CITY OF MADISON  
ZONING BOARD OF APPEALS  
APPEAL APPLICATION

1. The undersigned hereby appeals the decision of the Zoning Administrator in regard to Madison General Ordinance Section No. 28.068(5)

2. When relevant to a specific property, fill out below:  
Street Address: 414 Grand Canyon Drive

RE: Consideration of a conditional use in the Commercial Corridor (CC) district for a car wash at 414 Grand Canyon Drive. (LNDUSE-2020-00077; ID 61383)

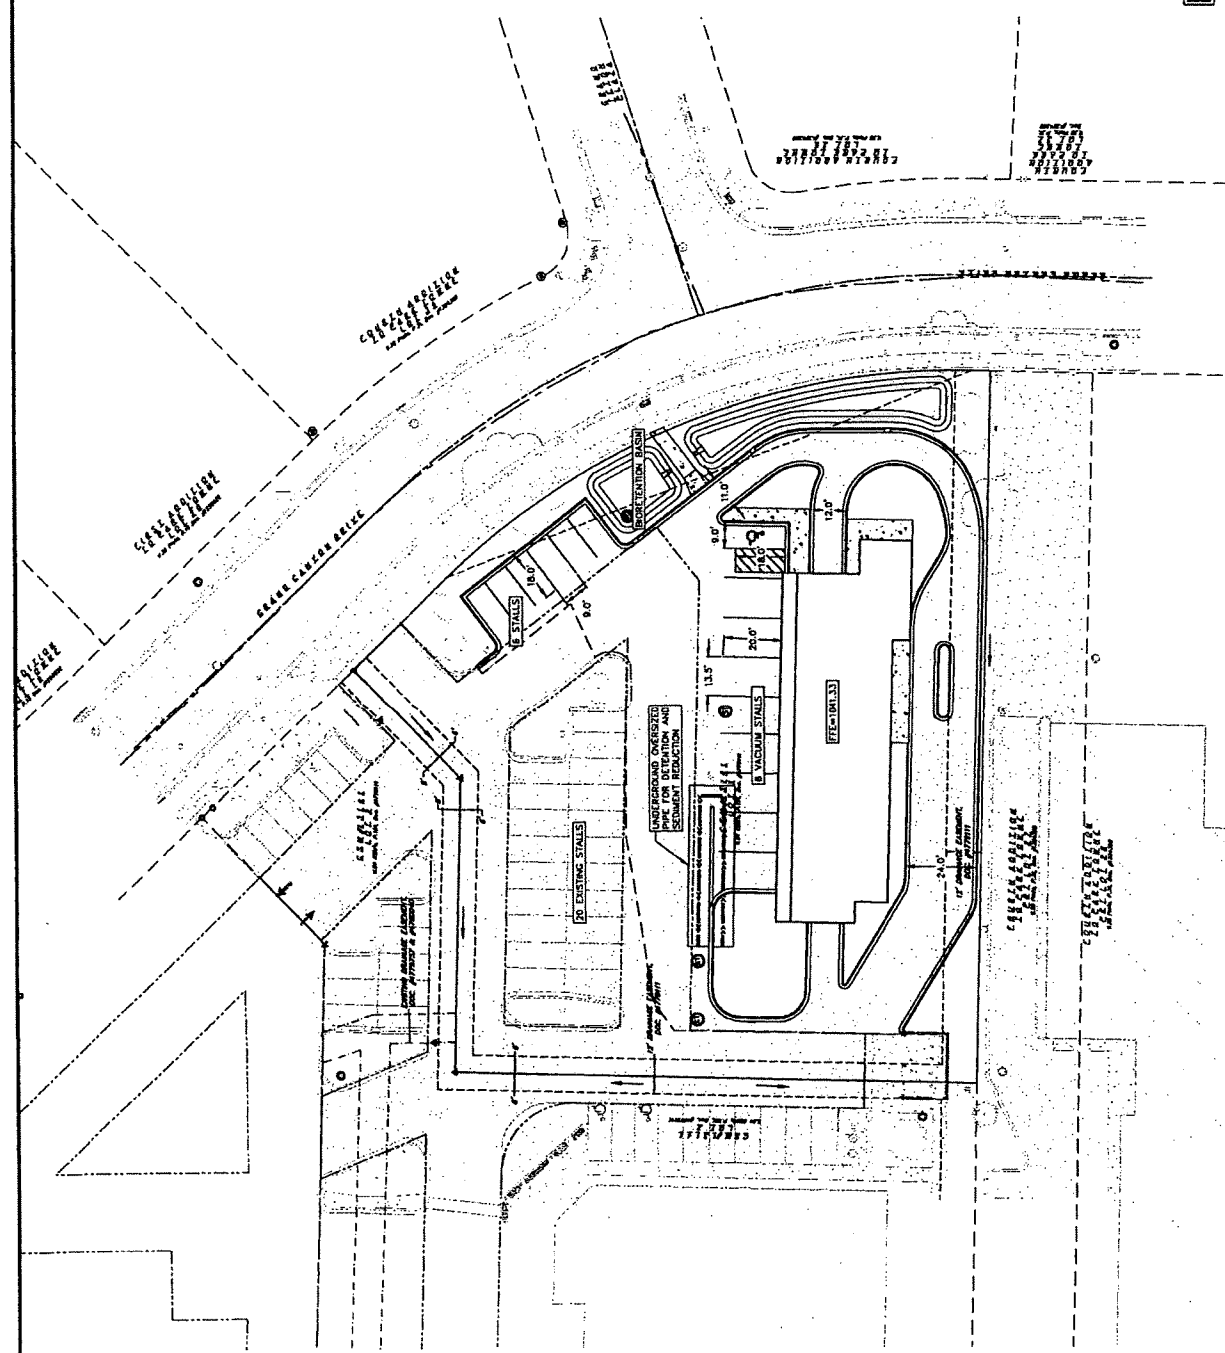
6. Show construction fence limits along back of sidewalk to protect sidewalk from damage.

7. Revise the site plan to show all existing public sanitary sewer facilities in the project area as well as the size, invert elevation, and alignment of the proposed service.

15. Provide a recorded agreement for the shared trash enclosure area at the southwest corner of this site. The existing REA adequately addresses all other reciprocal drainage, access, and parking between the three parcels (per Document Nos. 4779757 and 4780040).

23. "Stop" signs shall be installed at a height of seven (7) feet at all Class III driveway approaches, including existing driveways, behind the property line and noted on the plan. All directional/regulatory signage and pavement markings on the site shall be shown and noted on the plan.

24. One-way operation of the site shall be secured by placing a "One Way" sign at the entrance and a "Do Not Enter" sign at the exit.
25. The applicant shall provide a recorded copy of any joint driveway ingress/egress and crossing easements, which shall be noted on face of final site plan.

30. Show the building setback distances as measured to the front (east) and side (south) property lines. The front setback may be extended to a maximum of 100 feet if traffic circulation, drainage and or other site design issues are shown to require additional space.

34. Install screening along the south side property line. The screening shall be a minimum of six-foot tall masonry or decorative wood fence.
35. Provide details showing that the primary street façade meets the door and window opening requirements of Section 28.060(2)(d). For non-residential uses at ground floor level, windows and doors or other openings shall comprise at least 60% of the length and at least 40% of the area of the ground floor of the primary street facade. At least 50% of windows on the primary street facade shall have the lower sill within three (3) feet of grade.

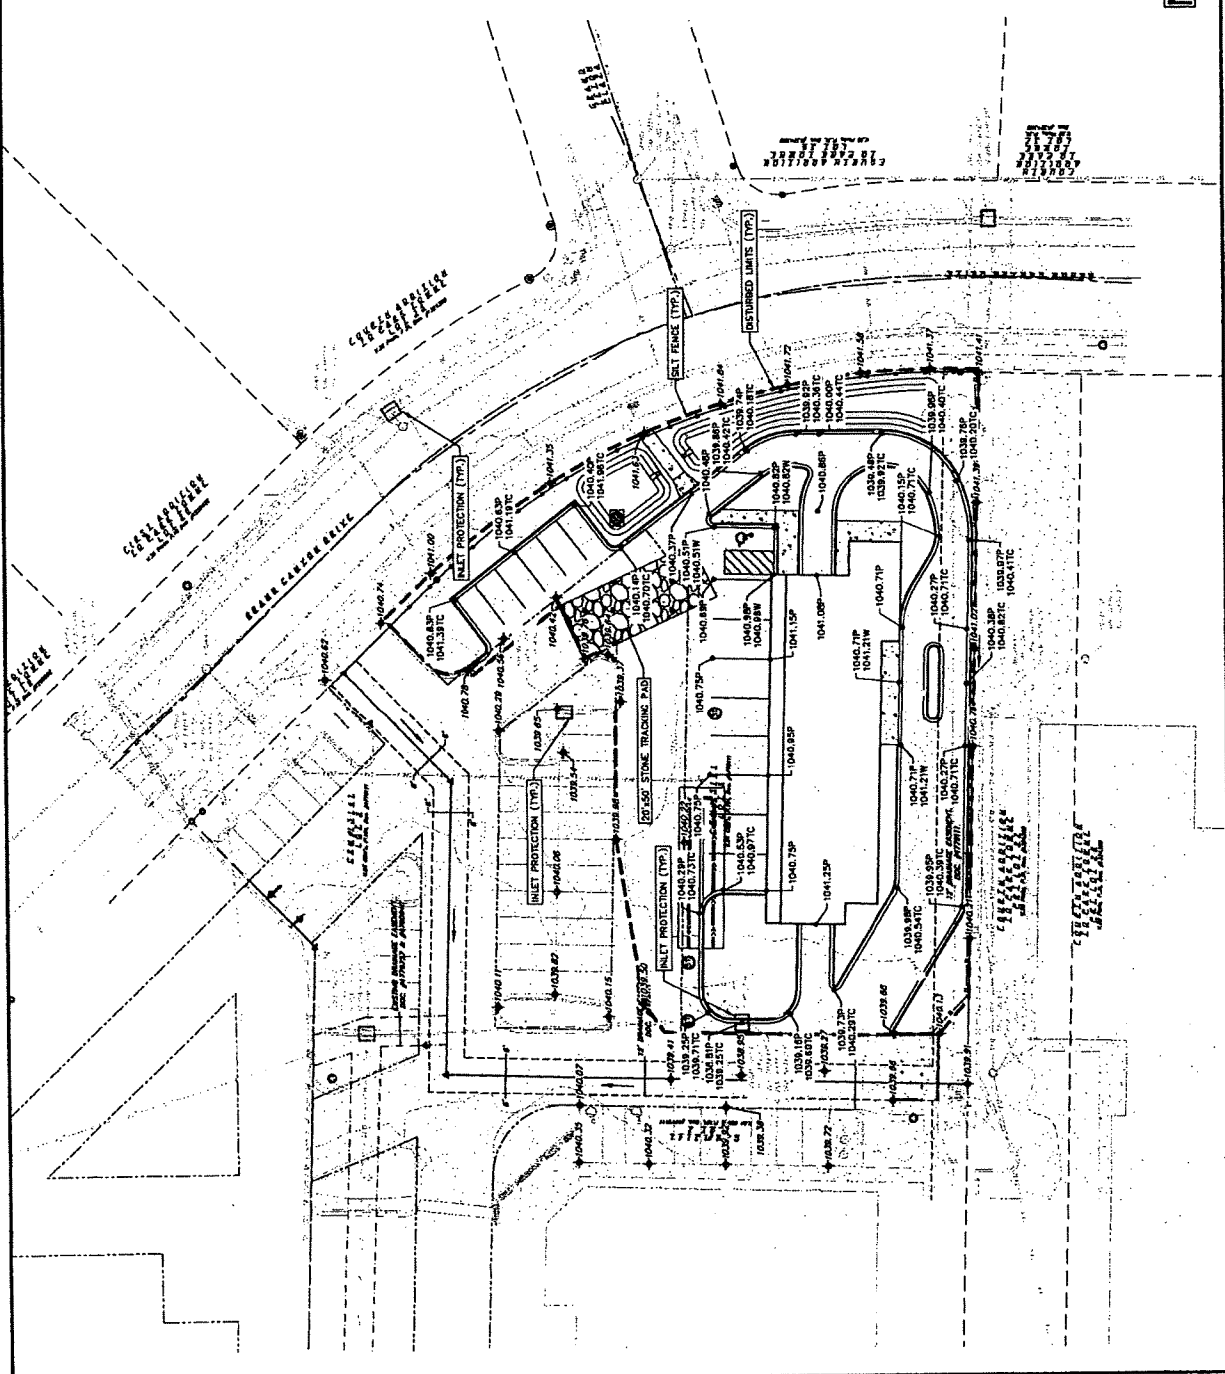
8. This project will disturb 4,000 sf or more of land area and require an Erosion Control Permit. Submit the Erosion Control Permit Application (with USLE calculations and associated fee) to Megan Eberhardt (west) at [meberhardt@cityofmadison.com](mailto:meberhardt@cityofmadison.com), or Daniel Olivares (east) at [daolivares@cityofmadison.com](mailto:daolivares@cityofmadison.com), for approval.

9. The applicant shall demonstrate compliance with Sections 37.07 and 37.08 of Madison General Ordinances regarding permissible soil loss rates. The erosion control plan shall include Universal Soil Loss Equation (USLE) computations for the construction period. Measures shall be implemented in order to maintain a soil loss rate below 5.0 tons per acre per year.

FIRST FLOOR PLAN

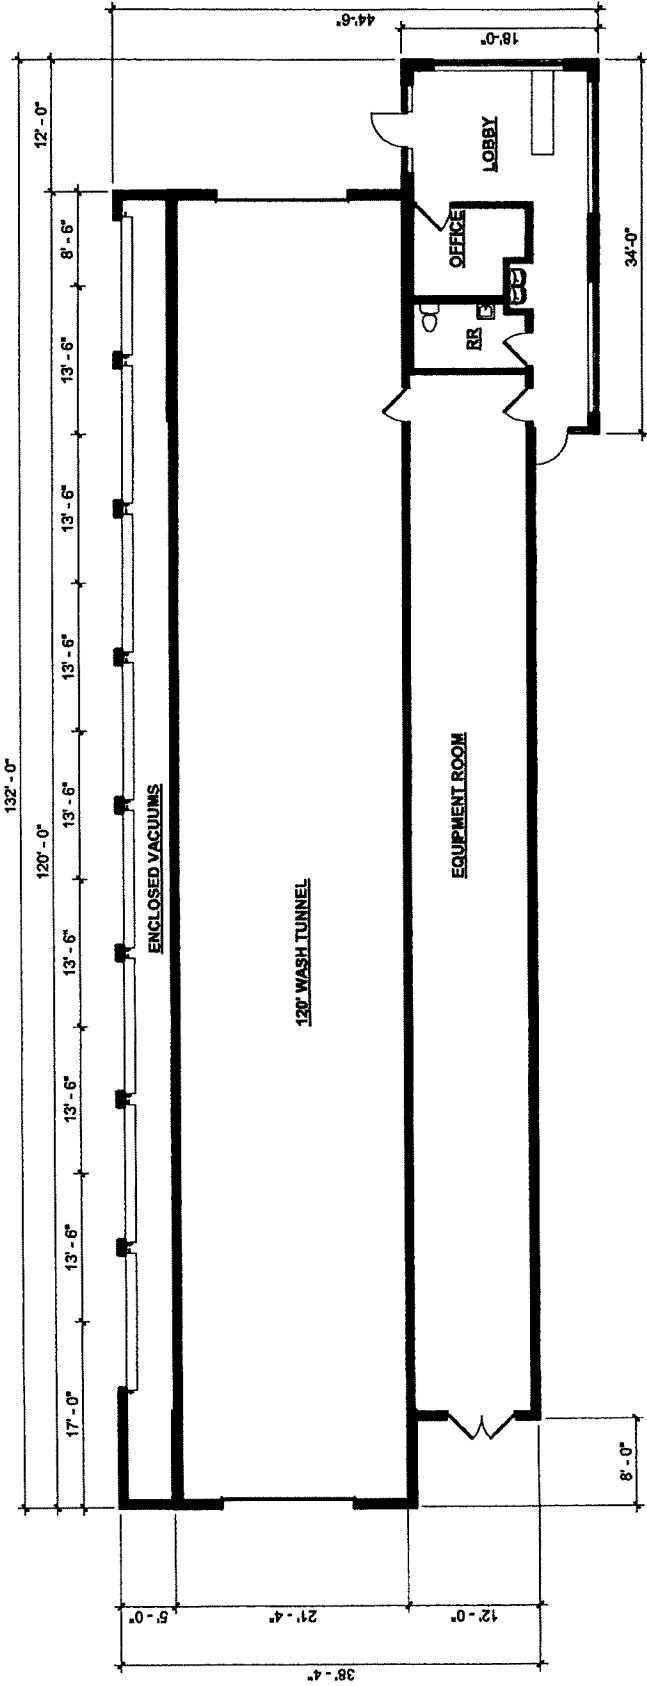
Bubble Time Express, LLC appeals from the Zoning Administrator's interpretation of Section 28.068(5) MGO as applied to the Bubble Time Express, LLC's project at 414 Grand Canyon Drive. More particularly, see condition 26 of the CUP conditional approval letter:

The vacuum stalls shall be fully enclosed. Per the site standards for new and existing development in the CC district per Section 28.068(5), all activities shall be conducted within completely enclosed buildings, except for the enumerated list. Emphasis added.

Per the Zoning Administrator's interpretation of Section 28.068(5) MGO, the vacuum system has to be contained/conducted within the enclosed building. Based upon that interpretation, the CUP application plans were prepared in compliance with that interpretation in order to not delay the CUP application. It is the position of the applicant that as applied to the Bubble Time Express,

LLC project, an exterior vacuum system (note with air pressure hose) is permitted. If the Zoning Board of Appeals grants this appeal, it is the intent of Bubble Time Express to revise its plans and seek an amendment to the CUP based upon revised plans for an exterior vacuum system with air pressure hose. See Exhibit E, photographs of the exterior vacuum system used by Bubble Time Express, LLC at its Denver, Colorado facility.

26. The vacuum stalls shall be fully enclosed. Per the site standards for new and existing development in the CC district per Section 28.068(5), all activities shall be conducted within completely enclosed buildings, except for the enumerated list.
